**Municipality of North Cowichan
Regular Council
ADDENDUM AGENDA**

7.6 Chemainus Library

Purpose: To consider requested amendments to development permit 000125 for changes to the design of the Chemainus Library.

Date	October 16, 2019	File: DP000125
To	Council	
From	Rob Conway, Director of Planning	Endorsed: 
Subject	Requested amendments to Development Permit 000125 (Chemainus Library)

1 SE PERSPECTIVE

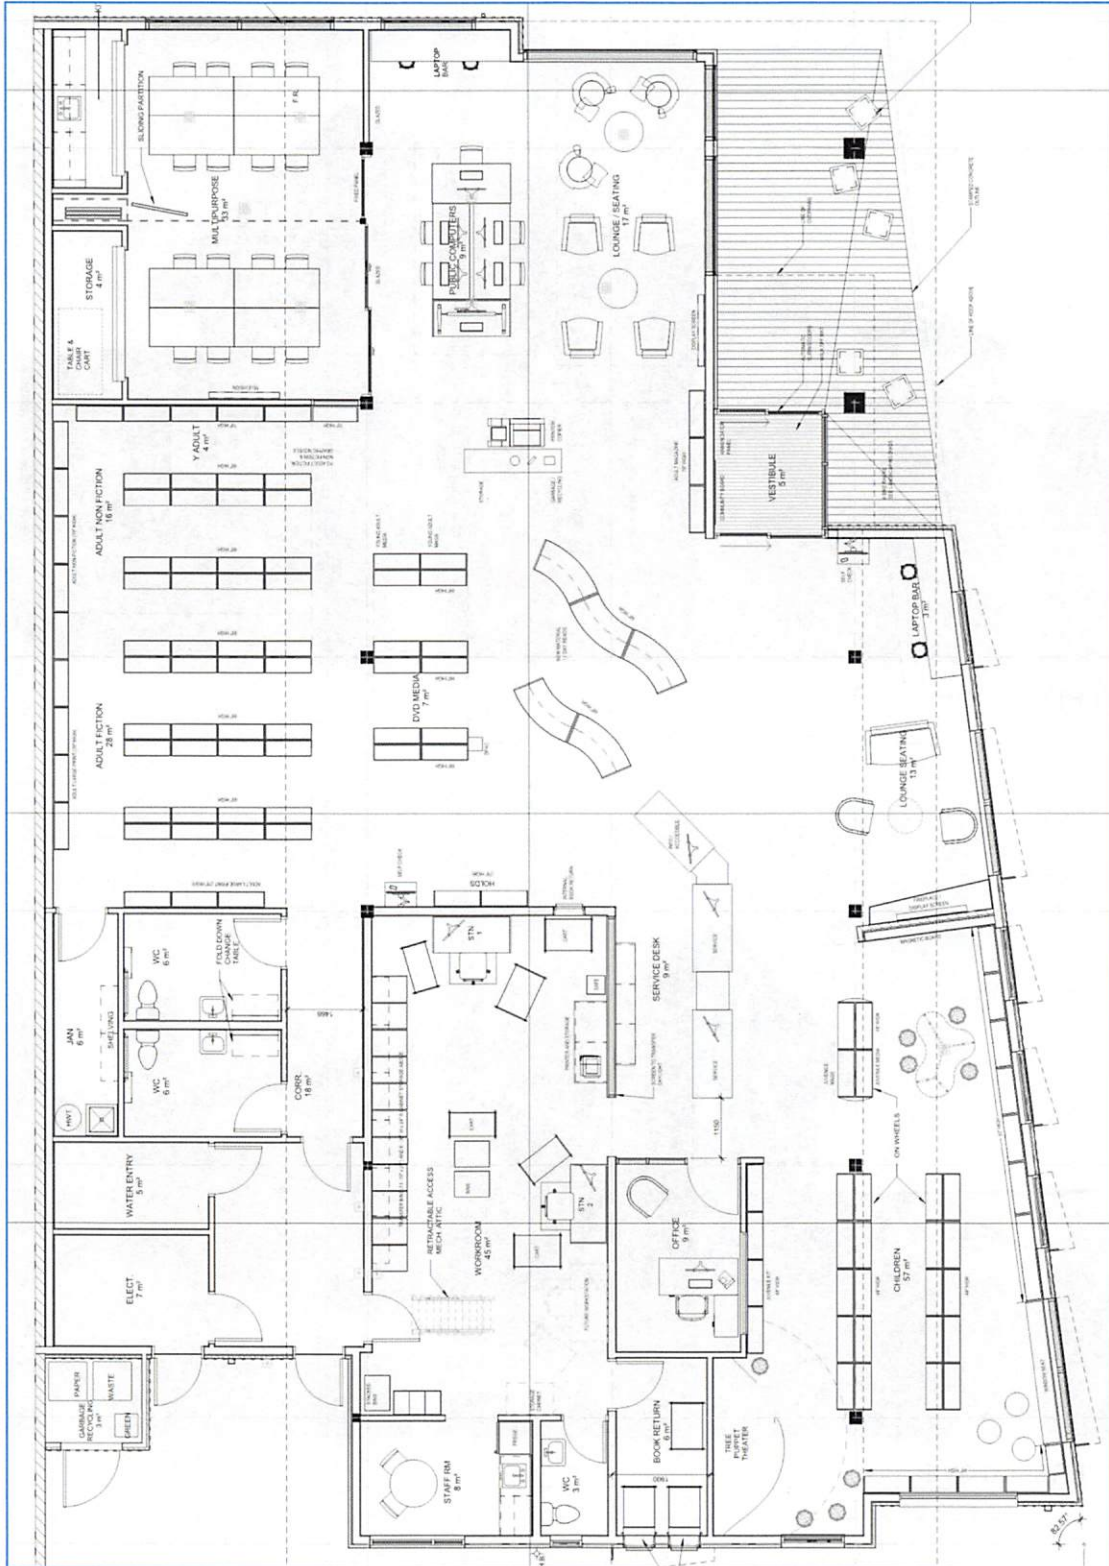
The approved design for the south east corner of the building included a large area glazing extending from near the base of the building up to the eave line of the structure. This feature was described in the original development permit submission:

An expanded area of glass, located at grade along the east and south elevations allows the patrons to maintain views and visual interactions with the two public streets, neighbouring park and murals. The windows facing Willow Street will offer views into the Lounge, Public Computer areas as well as views of the activities taking place in the Multipurpose Room to passer-by. ... In the evening, the glazed panels will allow warm and inviting interior views of the interior and its wood features.

The proposed amendment reduces the overall level of glazing in the south east corner, but the intended effect is generally maintained by the tall glass panels at the south east corner and the clerestory windows on other perimeter walls. As the applicable development permit guidelines do not require the amount of glazing that was originally proposed and, in the opinion of staff, the applicable development permit guidelines and design philosophy are maintained with the amended design, an amendment to the development permit to authorize reduced glazing in the south east corner of the building is recommended.

That Council approve the requested amendment to Development Permit 000125 (Chemainus Library) described in the October 16, 2019 staff report to reduce the area of window glazing in the south east corner of the building; and,

That the requested amendment to Development Permit 000125 (Chemainus Library) described in the October 16, 2019 staff report to reduce the area of window glazing in the south east corner of the building be approved and that the requested amendment to remove a canopy from the Willow Street elevation be denied.

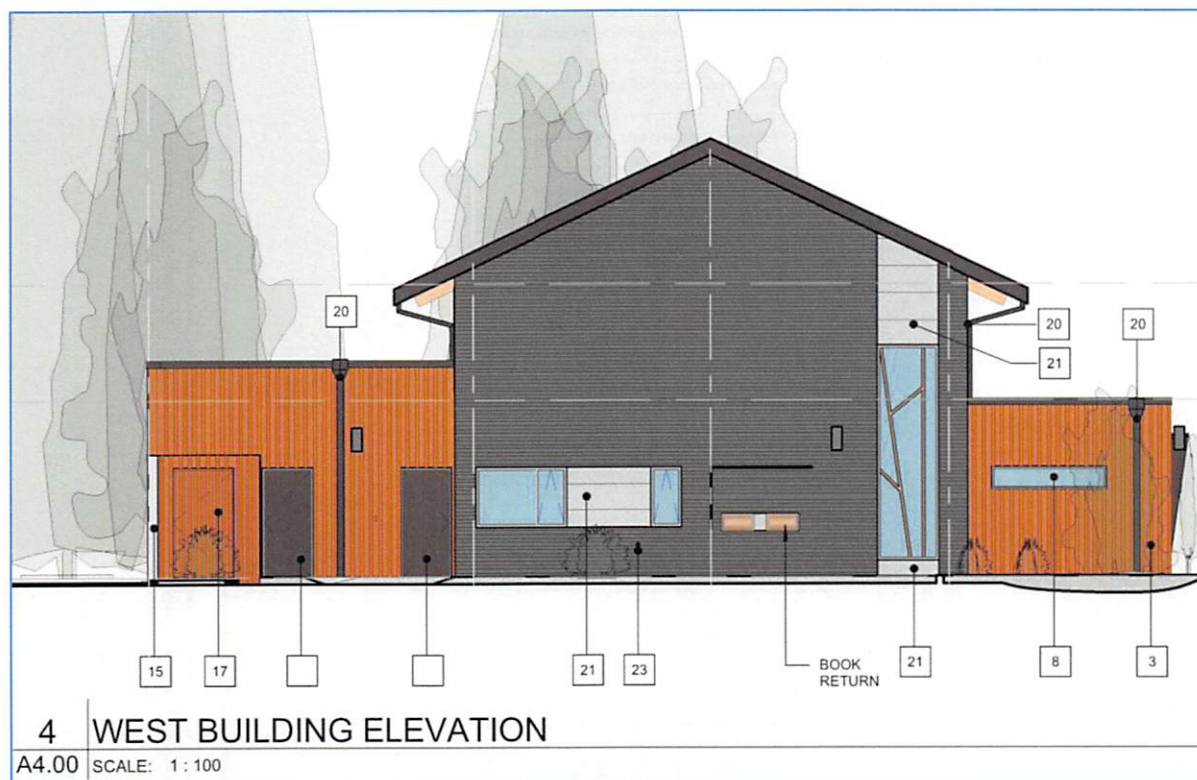
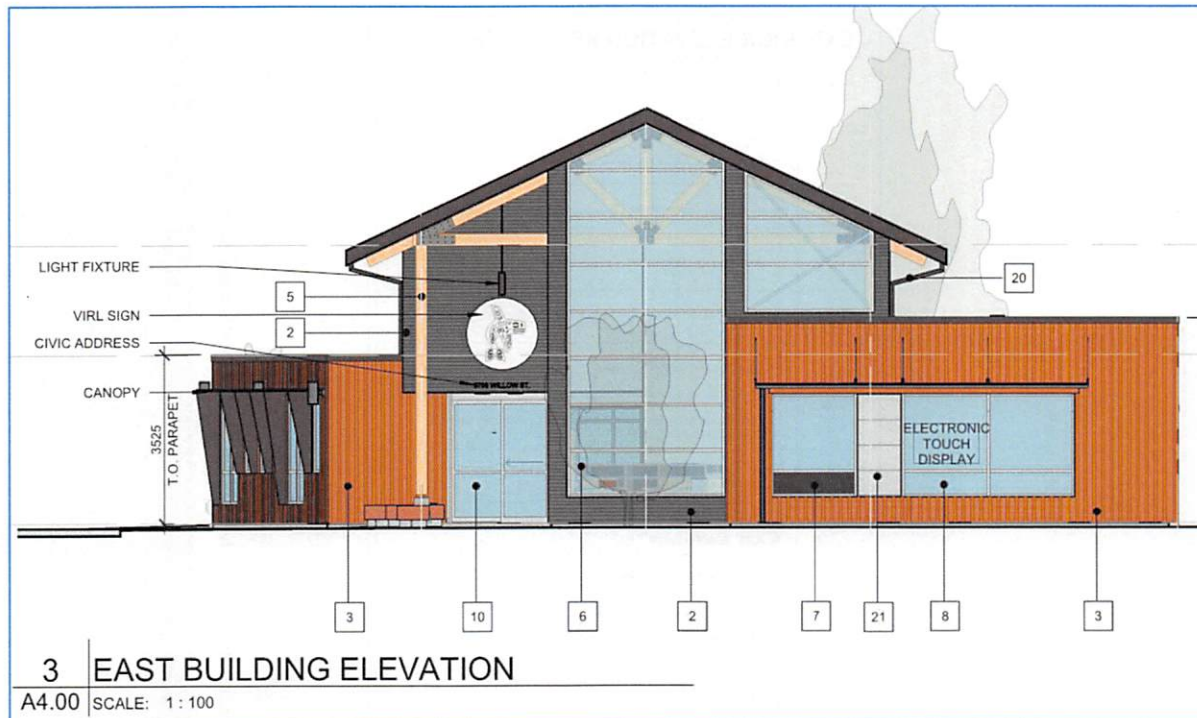
The second proposed design change is removal of a canopy on the Willow Street elevation of the building. Staff do not support this amendment because the canopy provides visual interest to the front of the building and enhances the pedestrian environment. Canopies are a common feature in the Chemainus town centre, particularly on Willow Street. They are also encouraged in the Chemainus Town Centre Revitalization Plan and applicable development permit guidelines. For these reasons it is recommended that the Willow Street canopy feature be maintained and that the requested amendment to remove it not be approved.

That Council deny the requested amendment to remove a canopy from the Willow Street elevation (Option 1).
